**Report to the Future Melbourne (Planning) Committee**

**Agenda item 6.4**

**Ministerial Planning Referral: Tpm-2013-17  
Dallas Brooks Centre, 282-336 Victoria Parade and  
300 Albert Street, East Melbourne**

**3 December 2013**

title: **GROUND FLOOR PLAN**

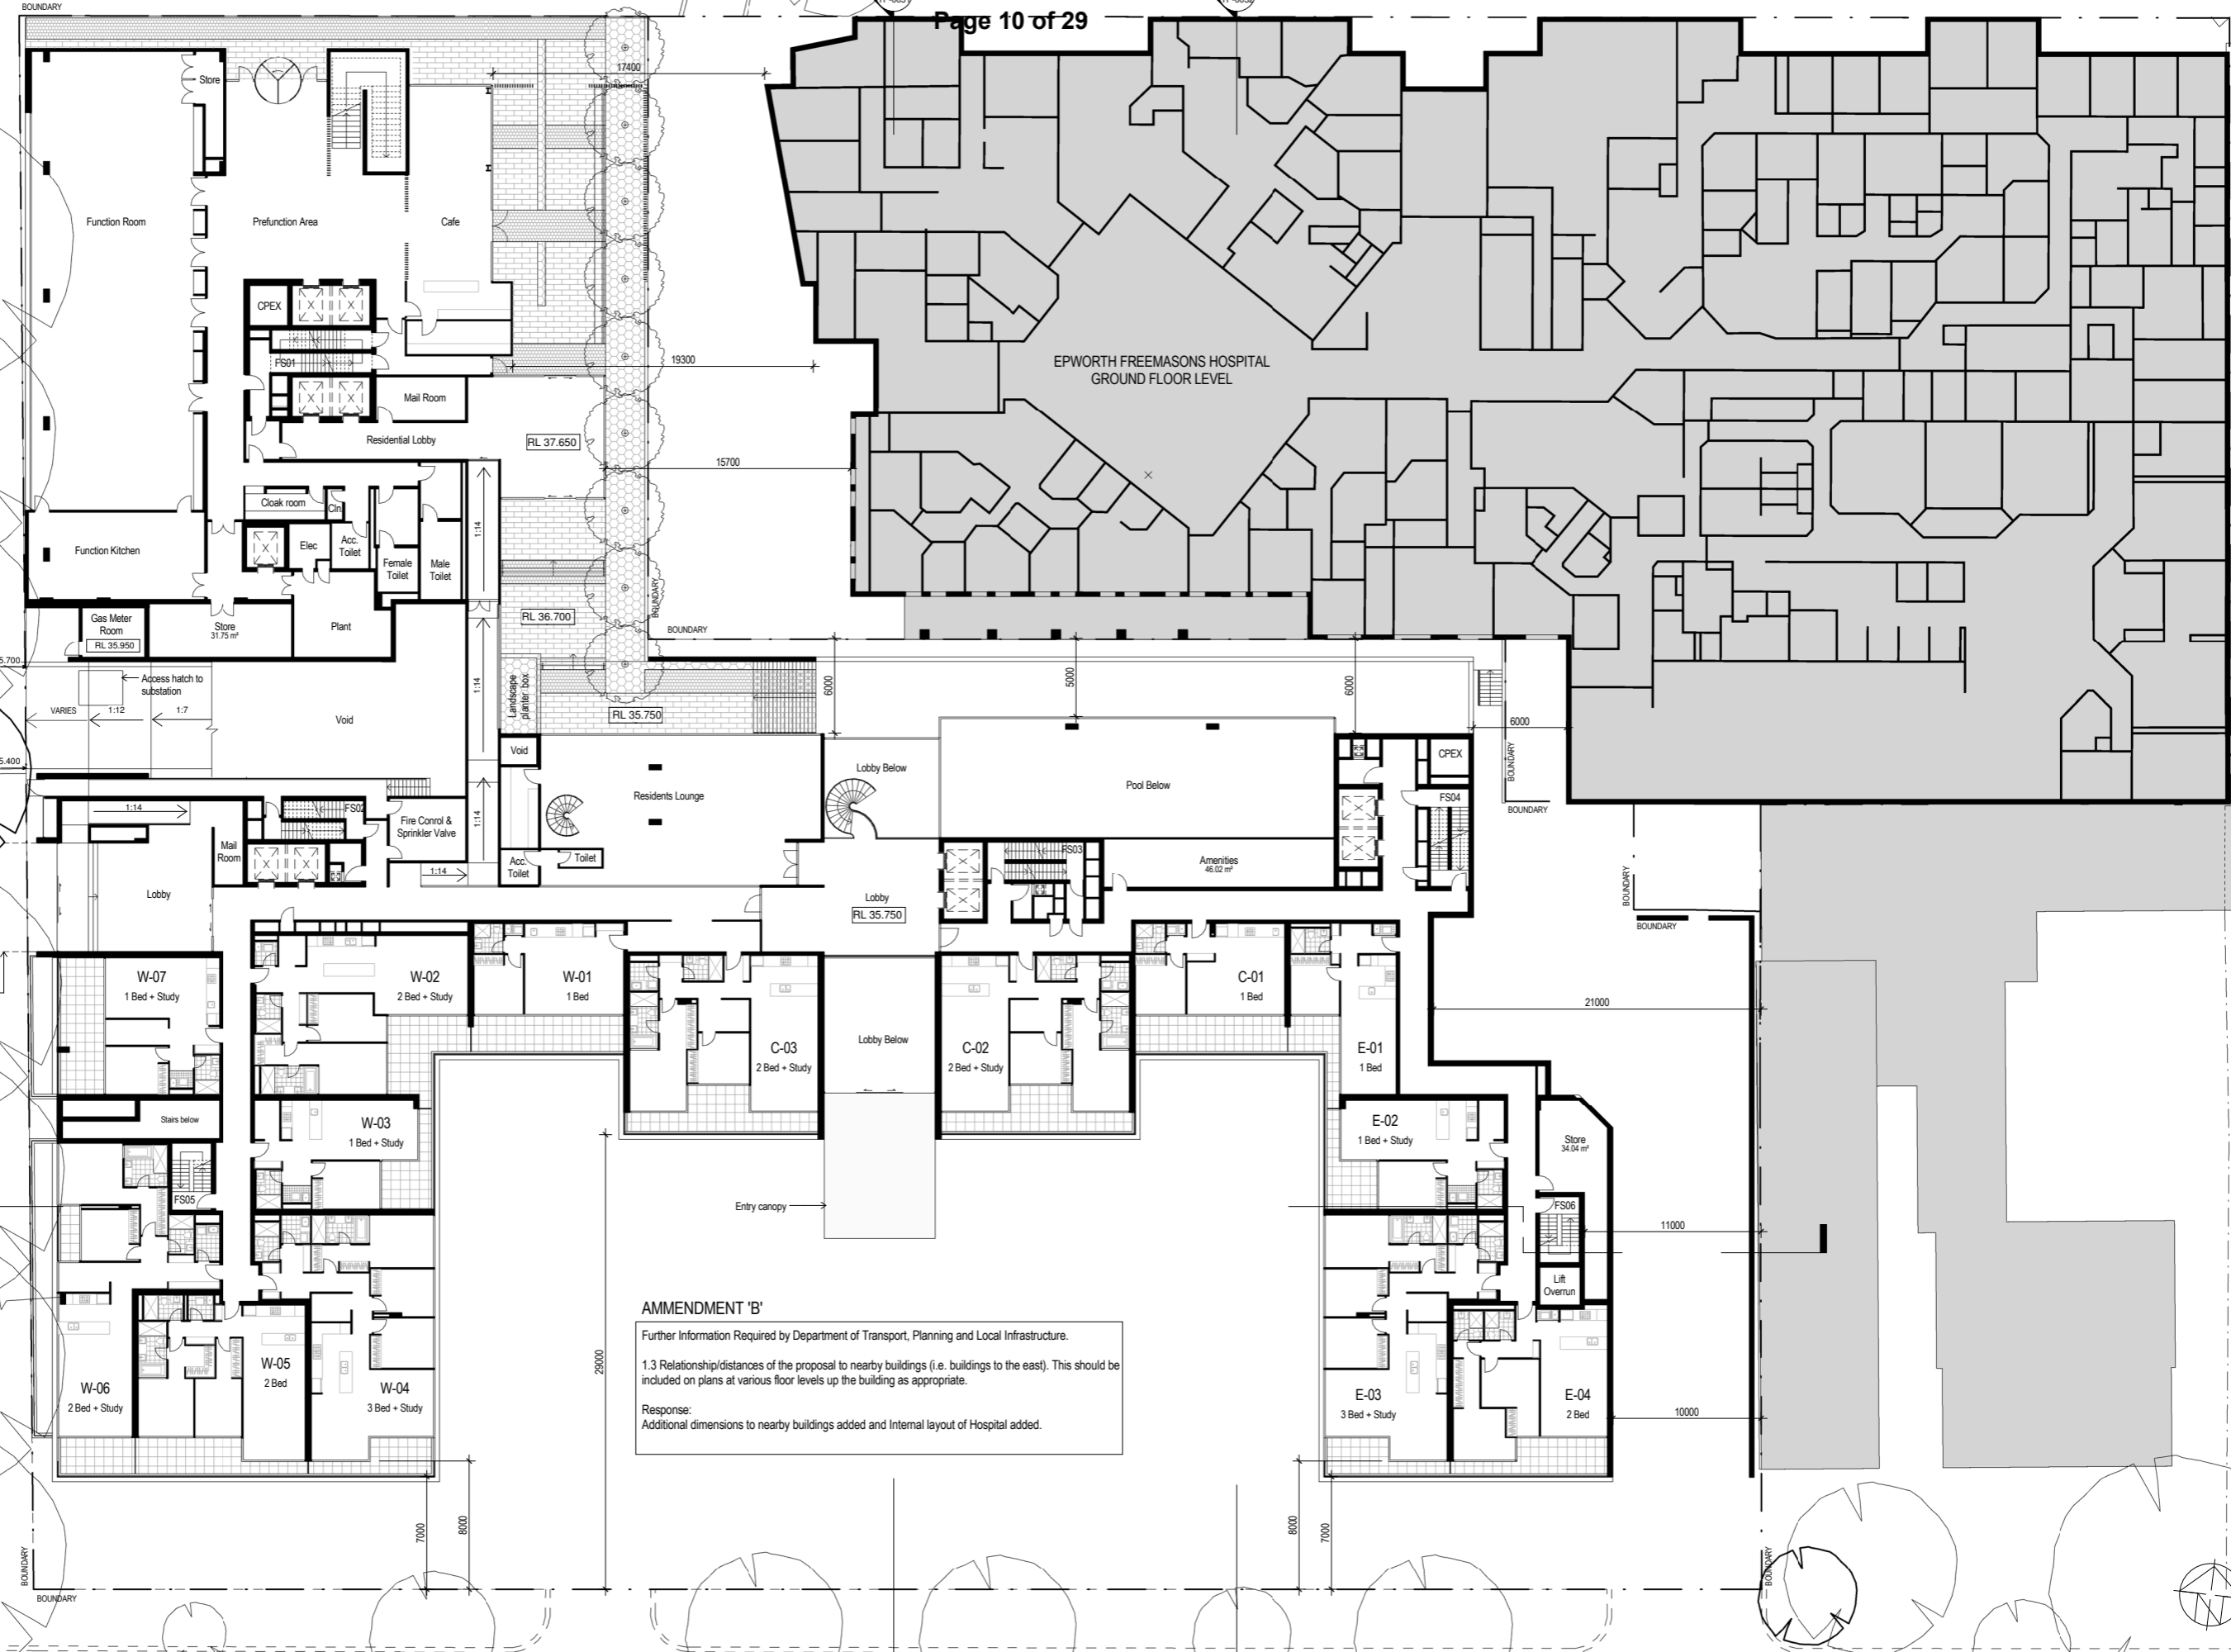
Further Information Required by Department of Transport, Planning and Local Infrastructure.

A) Relationship/distances of the proposal to nearby buildings (i.e. buildings to the east). This should be included on plans at various floor levels up the building as appropriate.

Response:  
Additional dimensions to nearby buildings added and Internal layout of Hospital added.

B) Bin store sizes amended to suit revised waste report.

Figure 12 – Examples of the existing height planes along Albert Street opposite Fitzroy Gardens

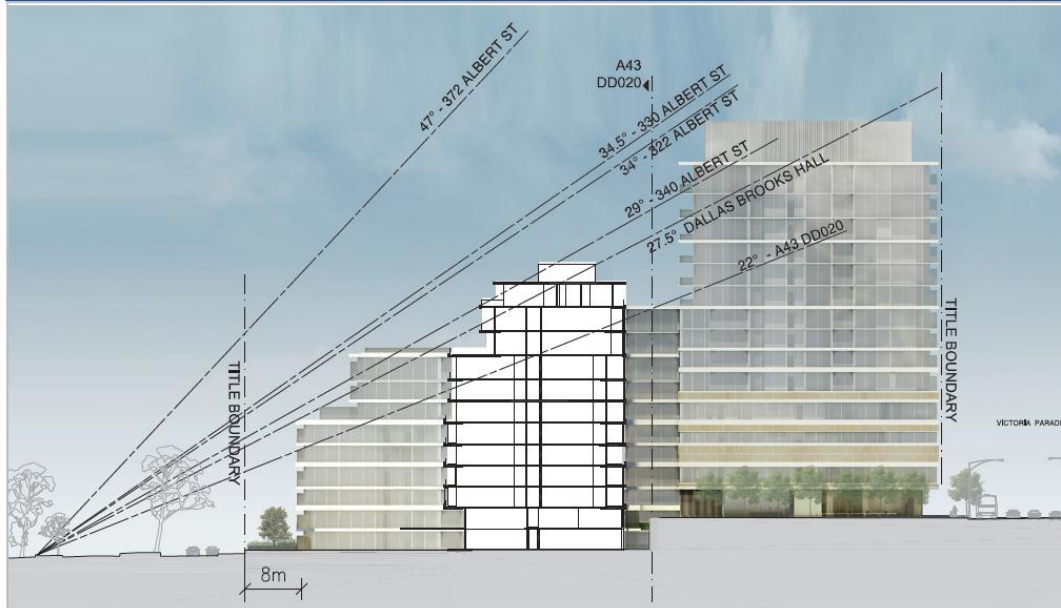
The noncompliance with the discretionary height control DDO20-38 has a flow on effect with the southern section of the development. The height of the northern section of the development is used as a justification to protrude above the discretionary height control of DDO20-A43 in the southern section of the site.

The southern section of the property is covered by Clause 43.02 Design and Development Overlay Schedule 20 – A43. The proposed building height and mass is inconsistent with DDO20-A43 which states that 'No buildings may be constructed that protrude above a plane inclined at an angle of 22 degrees from a point that is on the southern alignment of Albert Street...' (refer to the diagram below). The design outcome for this control is that 'New buildings or works do not impact upon the visual attractiveness of Fitzroy Gardens or create additional overshadowing on the gardens between 11.00 am and 2.00 pm on 22 March and 22 September'.

Even if approval is granted for a tower higher than 30 metres in Area 38, it would have a width of no more than approximately one quarter of the Albert Street frontage. A building within Area 43 and not directly behind the tower could not rely on the tower as a justification for protruding above the 22 degree plane, making it impossible for a responsible authority to conclude that the development conforms to the decision guideline. DTPLI officers have however obtained legal advice that the development is discretionary.
